July 23, 2008

Job No. 07489-3

Subject: Grading Plan Review and Update to Geotechnical Investigation
 Proposed Industrial Development - Sycamore V
 Lance and Sierra Drives
 Riverside, California

ENCLOSURE
1

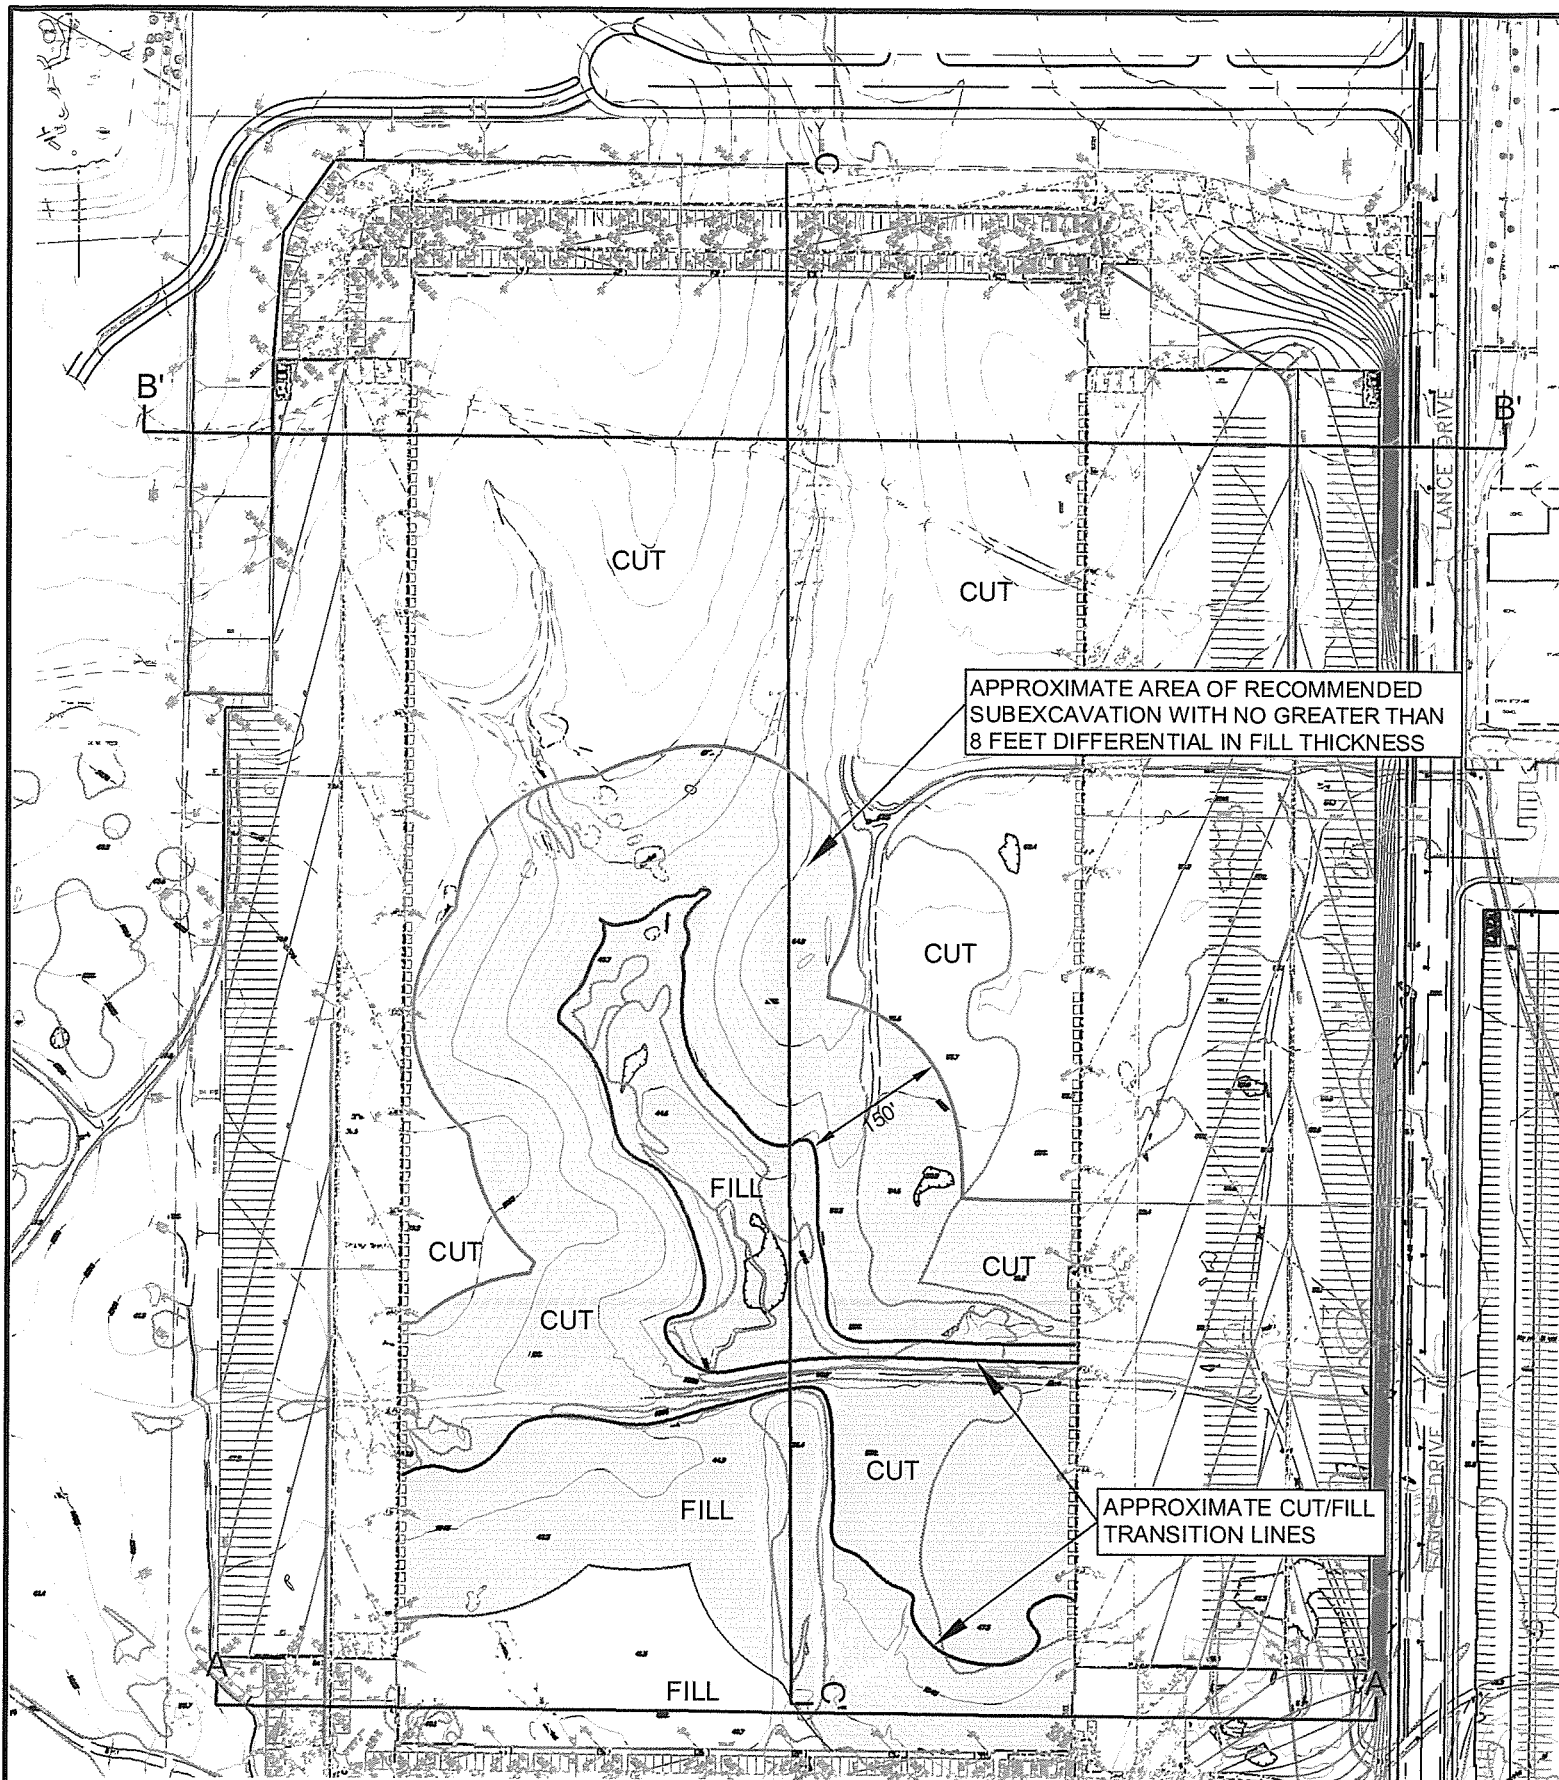
16 feet, when alluvial/colluvial removals are included. Cut-fill transition lines are present in the southern and central portions of the proposed building (Enclosure 1). In order to mitigate the potential for differential settlement across the cut/fill transition area, the pad area including areas underlain by bedrock, should be subexcavated to provide no greater than 8 feet difference in the fill mat thickness within 150 feet of the cut/fill transition line. The 150-foot distance from the transition line is also shown on Enclosure 1. The attached draft cross sections illustrate the cut/fill transition, areas of fill, bedrock cut areas, and potential fill depths beneath footings in rock areas. Our geotechnical investigation recommended a minimum fill thickness of 18 inches beneath all structure footings.
